Hume Coal Project (SSD 7172) and related Berrima Rail Project (SSD 7171) Comment on the Environmental Impact Statement (EIS)

Hume Coal Project (SSD 7172) and related Berrima Rail Project (SSD 7171) Request for comment on the Environmental Impact Statement DPI Water Detailed Recommendations

Hume Coal Project (SSD 7172) and related Berrima Rail Project (SSD 7171) Request for comment on the Environmental Impact Statement Watercourse Assessment Review

Figure 1. Valley settings of Wells Creek and Medway Rivulet. Note the combined Laterally Unconfined discontinuous chain of ponds and valley fill, fine grained reaches noted as broad green lines. These are highly fragile and rare/threatened River Styles® in the Hawkesbury-Nepean catchment.

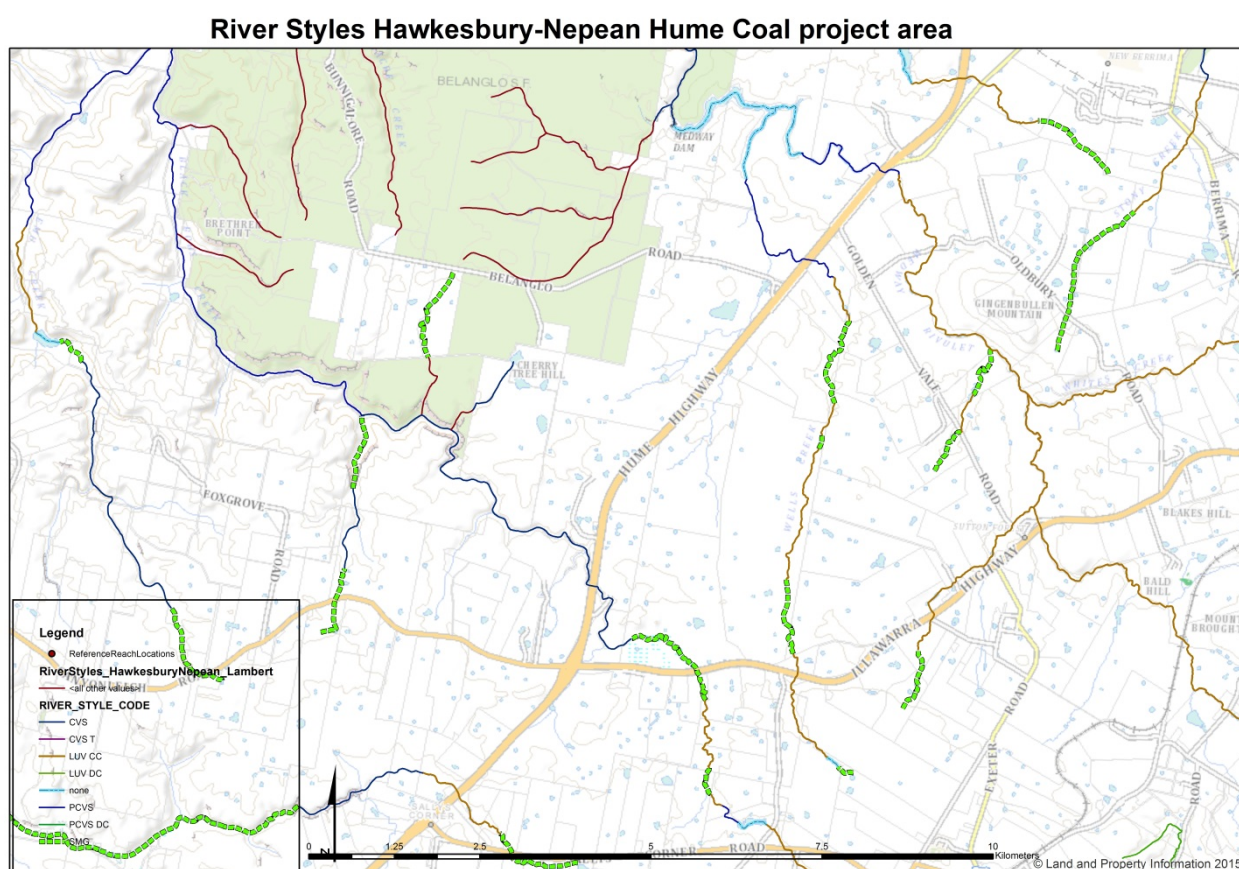
The highly sensitive reaches identified in Figure 1 are largely confined above farm dams and/or road crossings. These structures have the effect of preventing upstream knickpoint migration from incised and channelised reaches downstream of the remnant highly fragile reaches. Further disturbance to Wells Creek or Medway Rivulet may initiate further incision and degradation of these two rivers.

specified, as the high fragility reaches of Medway Rivulet, Belanglo Creek and Wells Creek are not identified in Figure 5.2 of Appendix E of the Environmental Impact Statement compared to the 2012 Department of Primary Industries – Water assessment. Appendix F of Appendix E of the EIS (Geomorphology assessment) contains survey information on watercourses lying within or adjacent to the mining area. Limited photographic records provide broad description of river character, but do not identify more fragile remnant river channel forms that have channelised into moderate fragility forms following European settlement.

It is important that the assessment should identify and protect those remnant channel forms, such as Laterally Unconfined chain of ponds and valley fill, fine grained reaches, as these River Styles[®] provide refuge to frogs and other species where pool storage levels remain intact during dry periods (Hazell et al. 2003). Although numerous scattered reaches of these River Styles[®] exist in the Wollondilly and Wingecarribee catchments, they are regarded as threatened due to the historic loss of the majority of these characteristic river forms, and their sensitivity to alteration and destruction should incision and channelisation between the remnant ponds occur (Mould and Fryirs 2017).

Response to pond drawdown in the remnant chain of ponds reaches identified from the DPI Water River Styles[®] is not discussed. No specific stream remediation or rehabilitation recommendations are provided, as the general assumption that no discernible impact will occur to streams or geomorphic features will occur. No specific commitment to remediation of streams, riparian zones or rare geomorphic features, such as remnant chain of ponds or partially saturated valley fills is made in the EIS.

Licensing of baseflow loss and management of flows where baseflows are affected should consider replacement or replenishment options. These could include geomorphic rehabilitation to replace and/or improve channel and pool condition.
